**DUKE POWER COMPANY**

Re: Catawba Nuclear Station  
Docket Nos. 50-413 and 50-414

On February 22, 1983 the NRC issued the Safety Evaluation Report (SER) for the Catawba Nuclear Station. The design of the diesel generator intake and exhaust system is noted as an open item in Section 1.7. As discussed further in Section 9.5.8:

DIESEL GENERATOR AREA -  
 UNIT 1 GENERAL ARRANGEMENT  
 CATAWBA NUCLEAR STATION  
 Figure 9.5.8-2  
 Revision 8  
 CN-1200-14.1

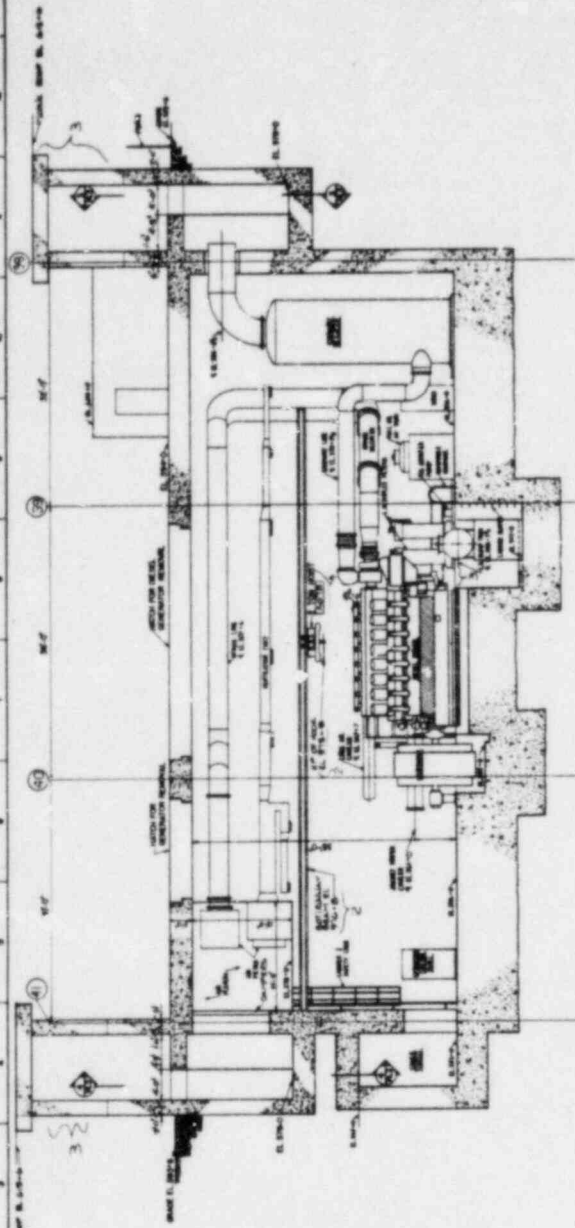
- 1) The applicant has not submitted sufficient information on the blockage of the intake and exhaust openings as a result of ice and freezing rain.
- 2) The applicant has not submitted any drawings on the redesigned intake and exhaust structures.

- 1) The intake and exhaust structure louvers are recessed in the structural openings and protective overhangs are provided in accordance with ASHRAE recommendations for "Inlet and Outlet Design for Weather and Dust Protection". Louver spacing is greater than 4 inches between blades, thus providing adequate space for ice buildup on the blades without encouraging blockage. As previously stated, velocity and corresponding pressure drop are low enough to prevent blade icing from compromising the intake and exhaust system's performance.
- 2) Attached are revised general arrangement drawings which show the redesigned diesel generator intake and exhaust structures. These figures will be included in Revision 8 to the FSAR.
